MATANUSKA-SUSITNA BOROUGH

ABBREVIATED PLAT AGENDA

STAFF REVIEW AND RECOMMENDATIONS
PUBLIC HEARING
November 6, 2024

ABBREVIATED PLAT: CARNEY HOMESTEAD
LEGAL DESCRIPTION: SEC 14/15, T18N, R01W, SEWARD MERIDIAN AK
PETITIONERS: DAN CARNEY
SURVEYOR/ENGINEER: APB LAND SURVEYING / HANK WILSON
ACRES: 47.00 ± PARCELS: 4
REVIEWED BY: MATTHEW GODDARD CASE #: 2024-119

FLOODZONE MAP

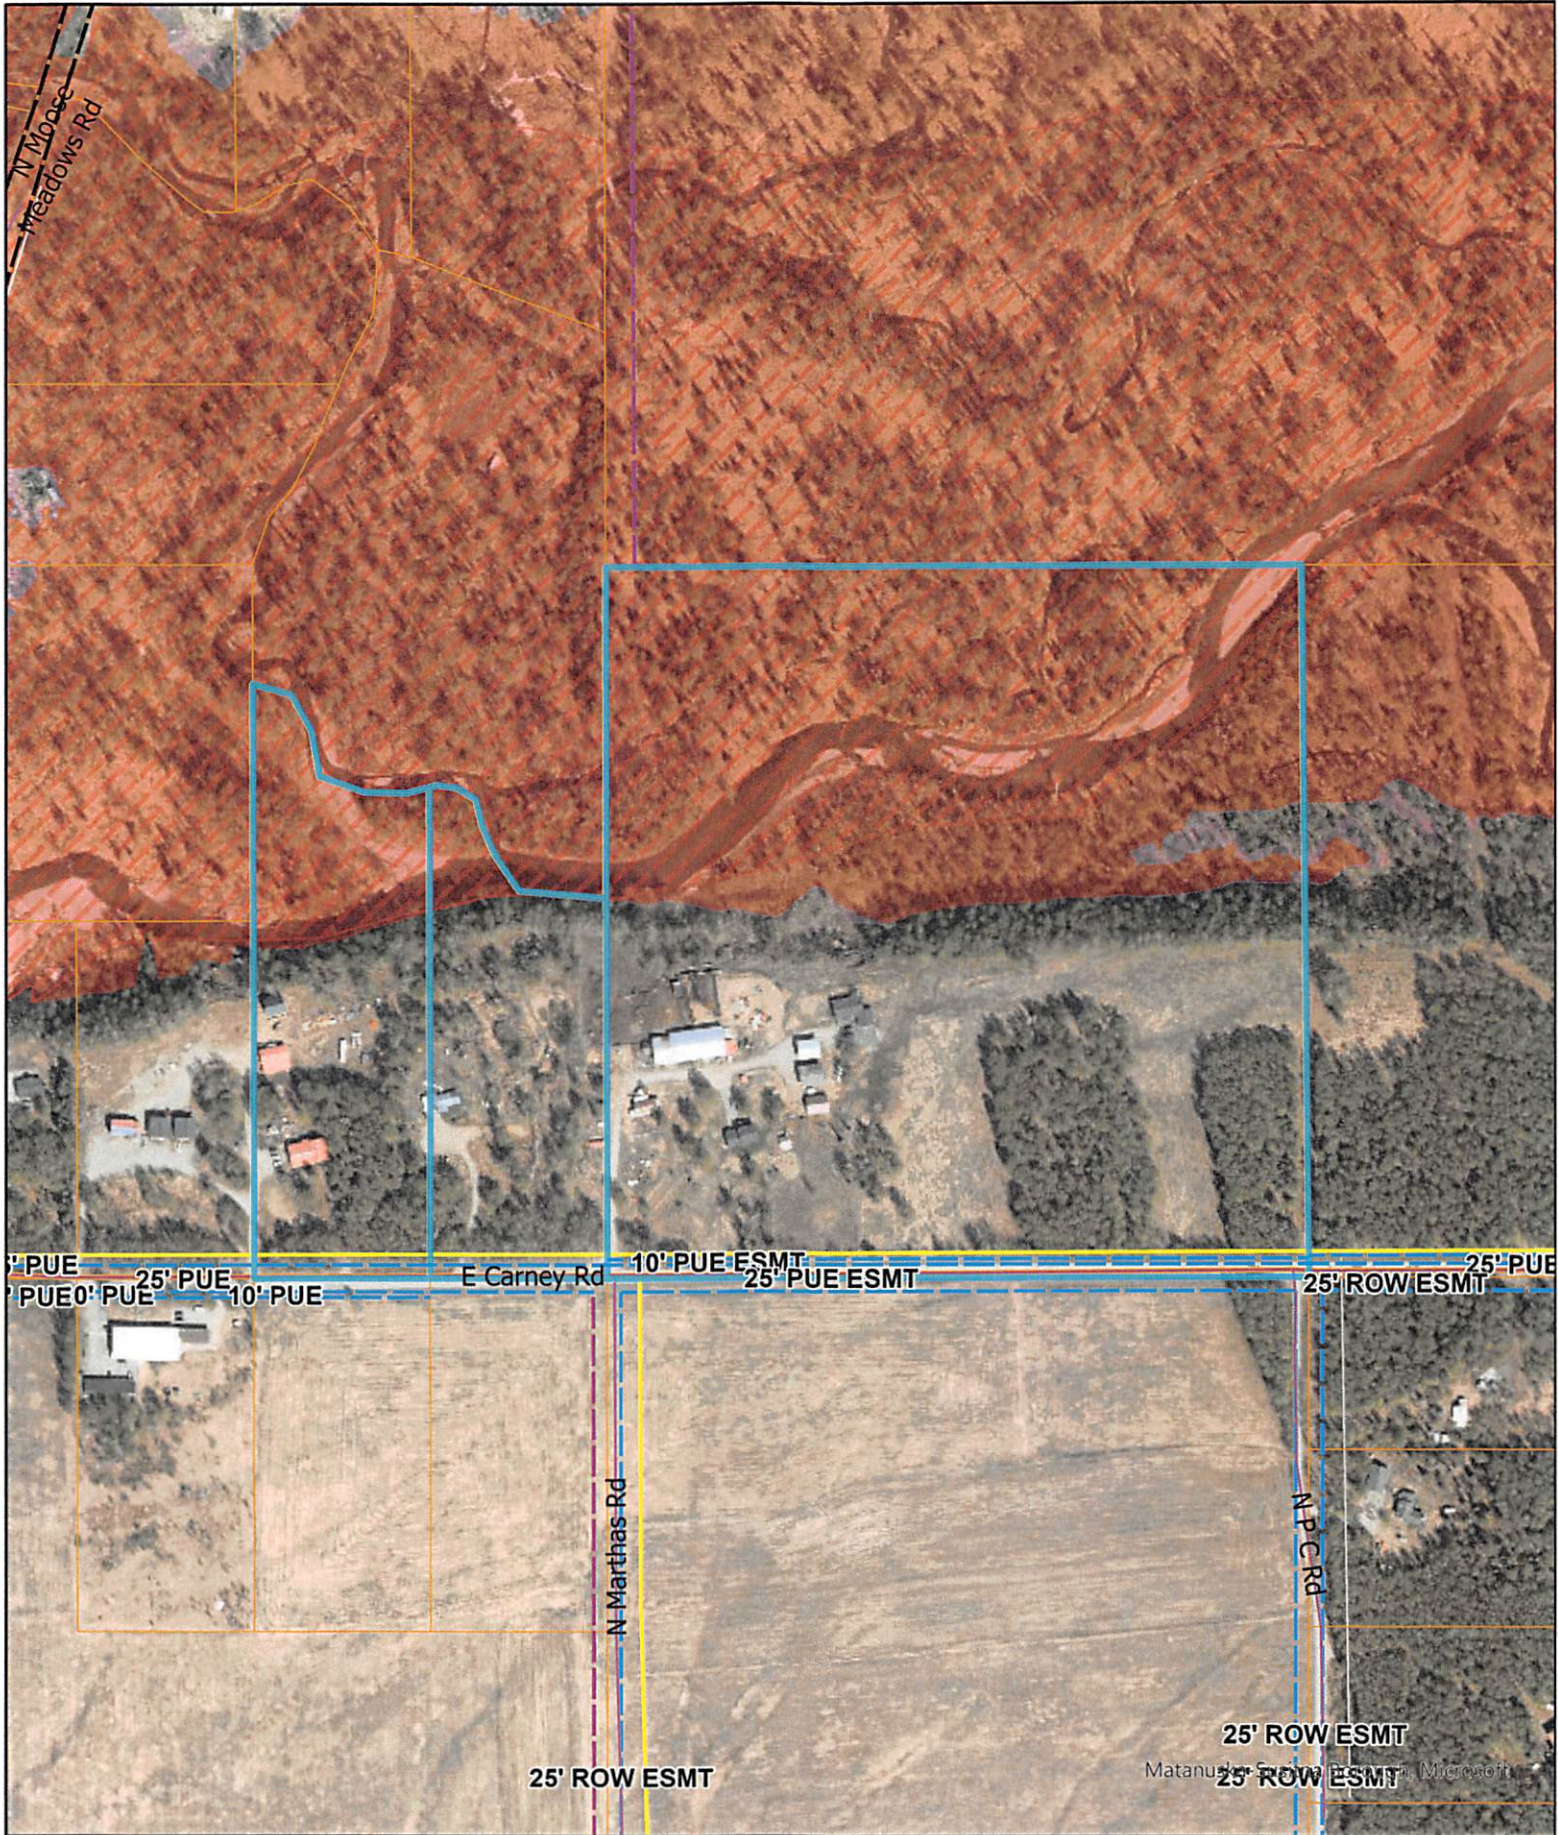
MSB Planning (**Exhibit E**) notes that it appears that the north segments of A23 and A22 are not included in this action. What is the disposition of these two segments? If these segments are to be determined to be part of A19 or a separate parcel, the following is attributable to all the parcels where the floodplain/floodway exists per MSB 17.29, which regulates all the areas in the flood zone with development standards.

A permit must be obtained prior to any development within the flood zone. If development is within the floodway designation, it requires a hydraulic analysis with a no-rise certification completed by a licensed and registered Professional Engineer who can perform work in Alaska.

Platting staff notes after inquiry to the surveyor, he has confirmed that the property boundary as depicted is accurate per the recorded deeds. The northern boundary of the existing Parcel A23 and A22 follows the boundary of the Little Susitna River.

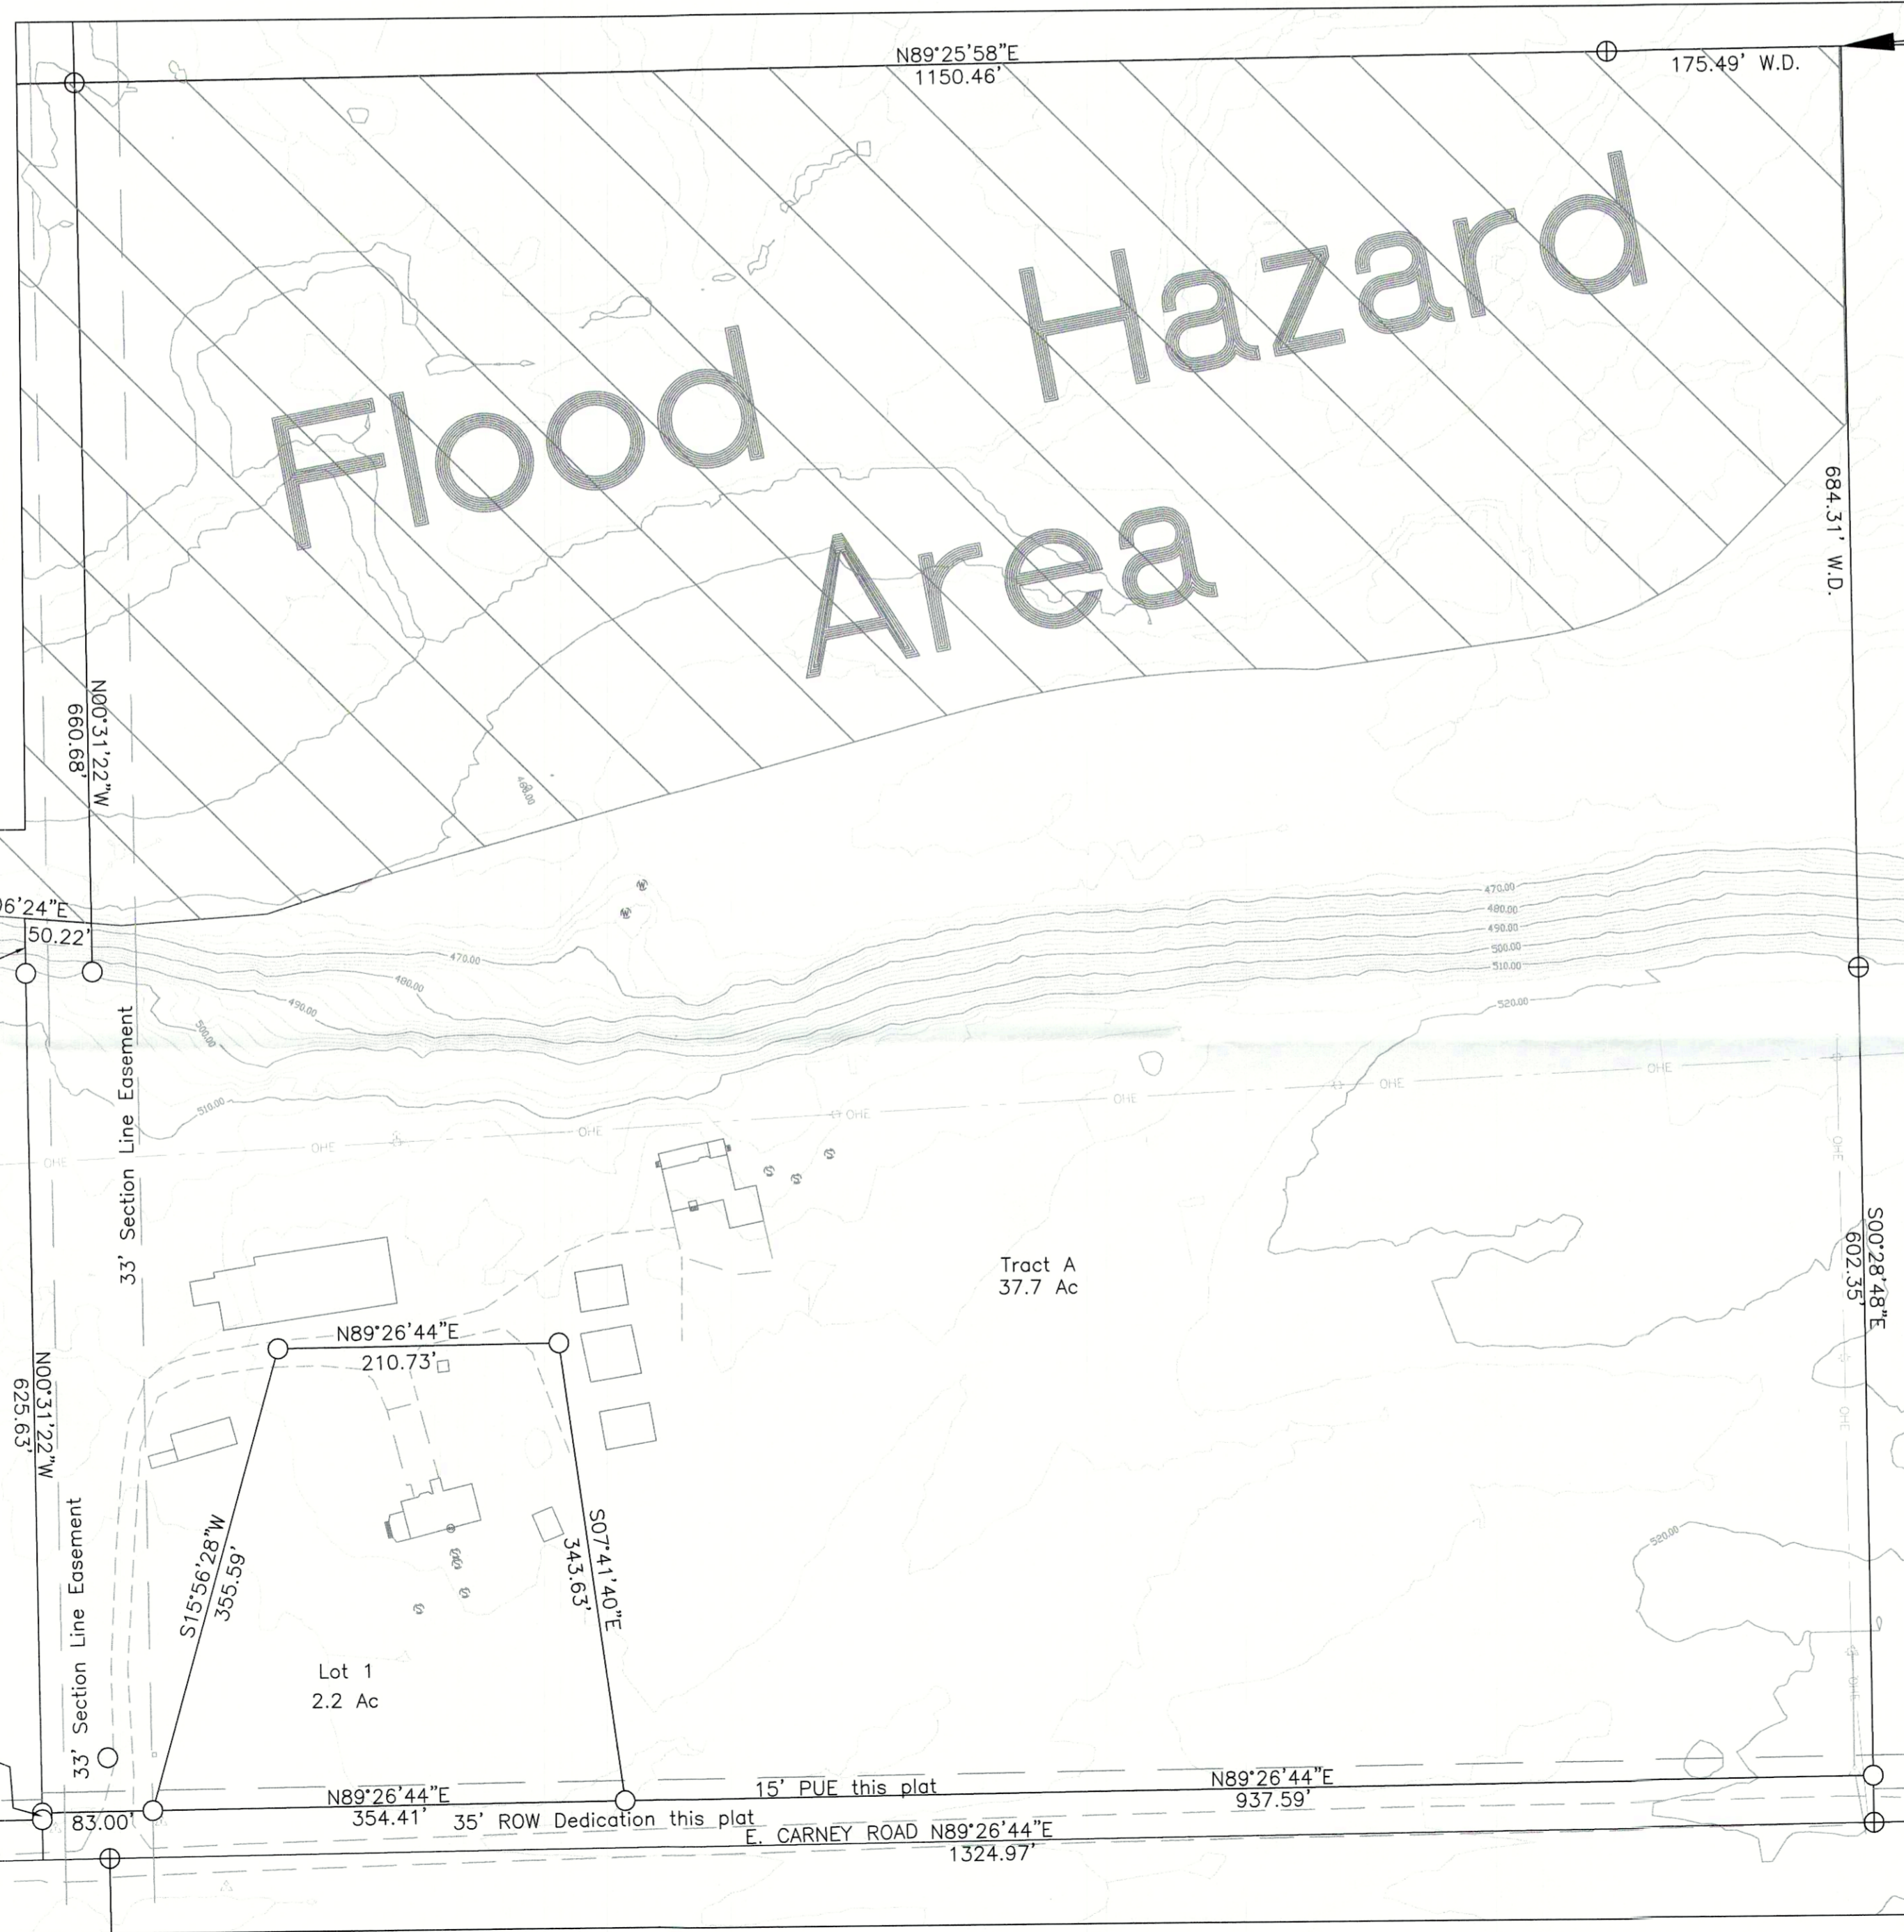
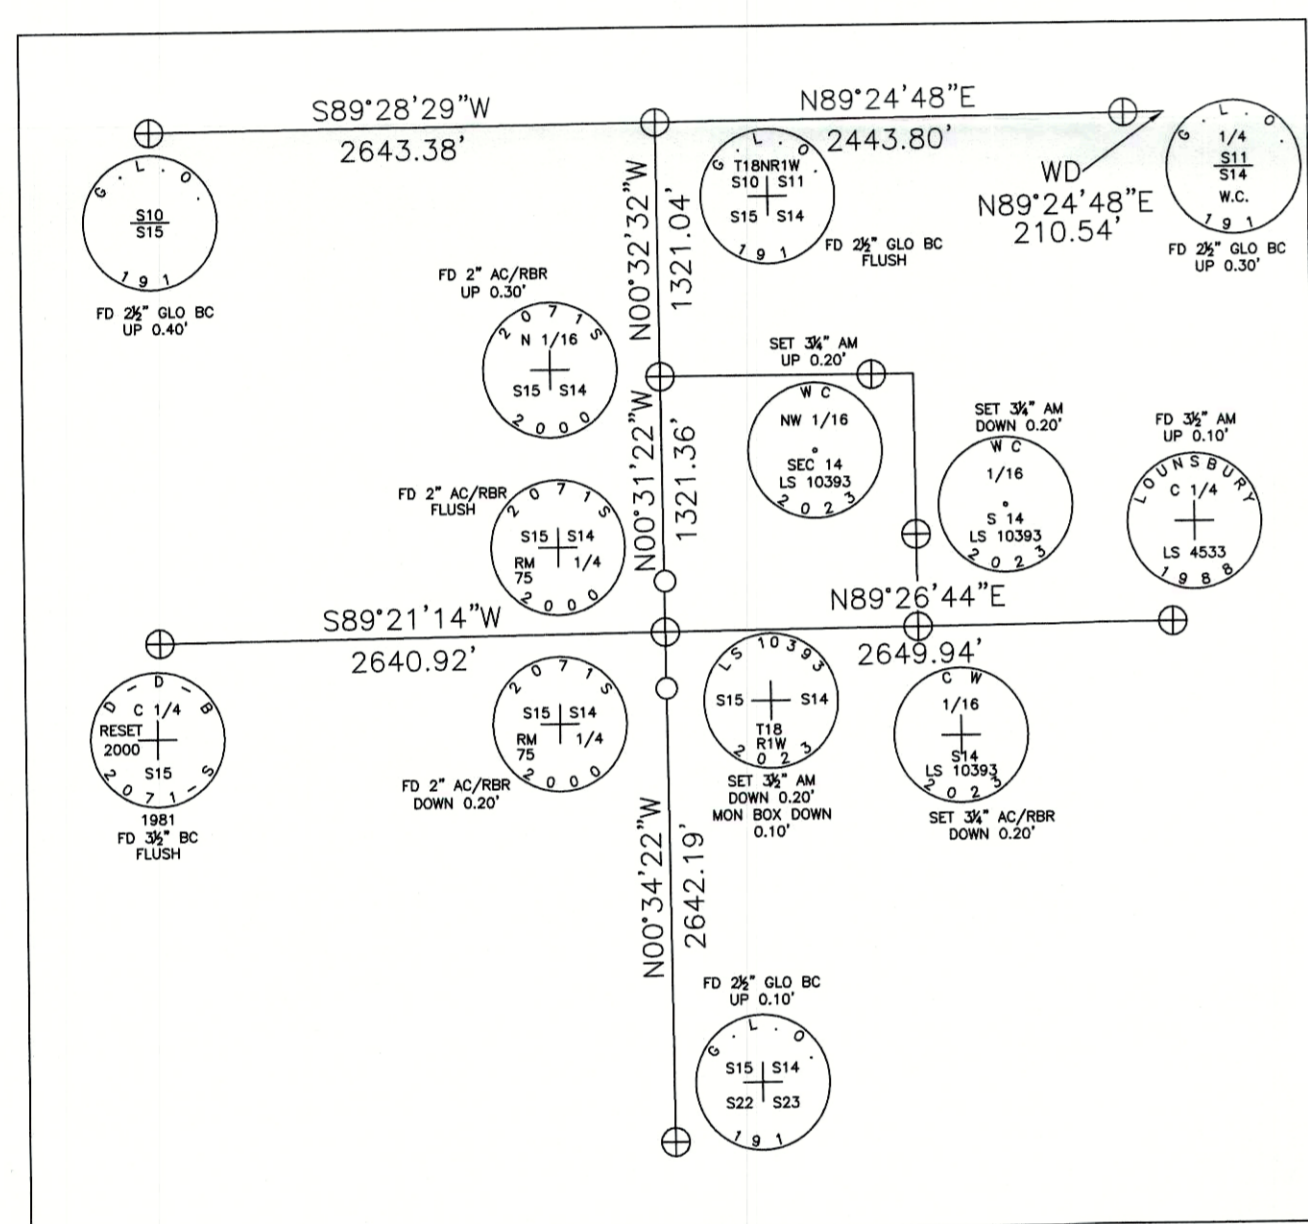
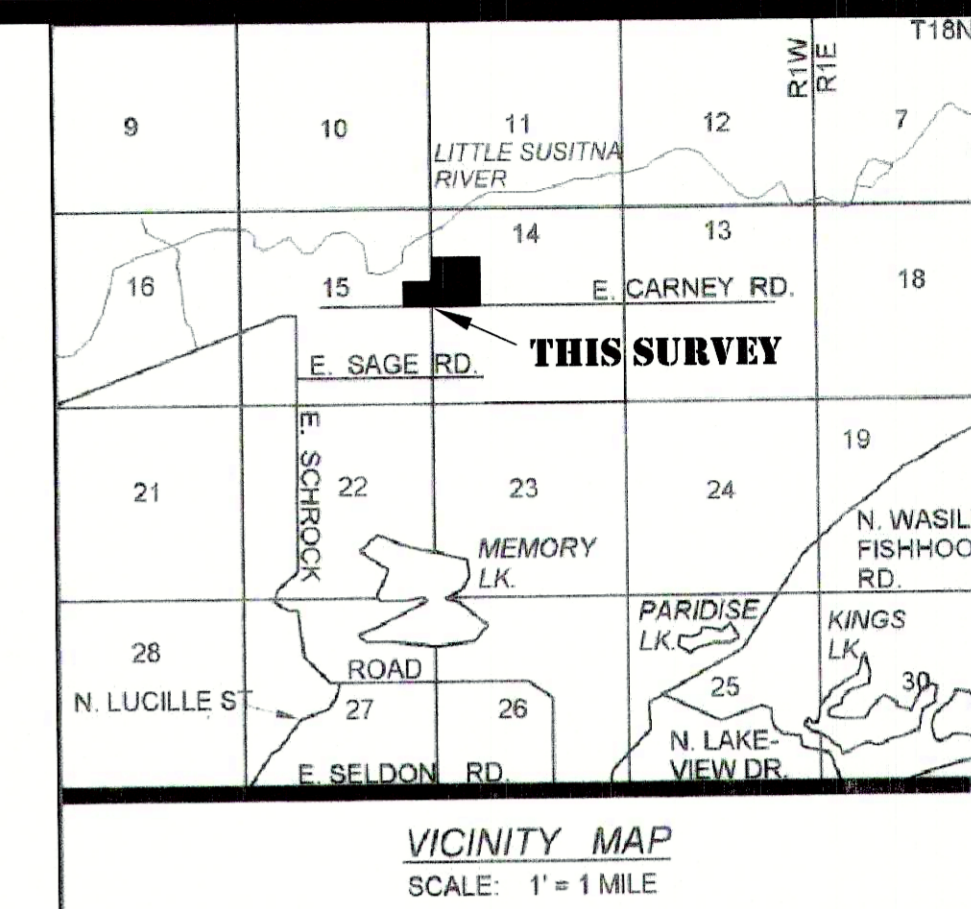
- As Carney Road is a major collector on the OSHP, direct access should be minimized to the extent possible.
- Provide a site plan showing the location of all of the test holes. Include contours.
- The surveyor should confirm the existence of all section line easement involved in the plat.
- Add the following to the platt notes:
 - Easement Bk 161, pg 919
 - Easement Bk 157, pg 615
 - Document #2005-020220-0

*Platting staff notes that all easements of record will be shown on the final plat (**Recommendation #8**).*

3. Pay postage and advertising fees.
4. Add a common access easement for Lot 1 and Tract A.
5. Add a plat note stating "Tract A and Lot 1 to share a common access on E. Carney Road unless otherwise authorized by the permitting authority."

6. Submit a site plan showing the location of all test holes. Include contour mapping on the site plan.
7. Submit section line easement determination for the portion of section 14 and section 15 included in this platting action.

8. Remove the right of way dedication and public use easement dedication from the plat. Adjust property boundaries to reflect this alteration.
9. Show all easements of record on final plat.
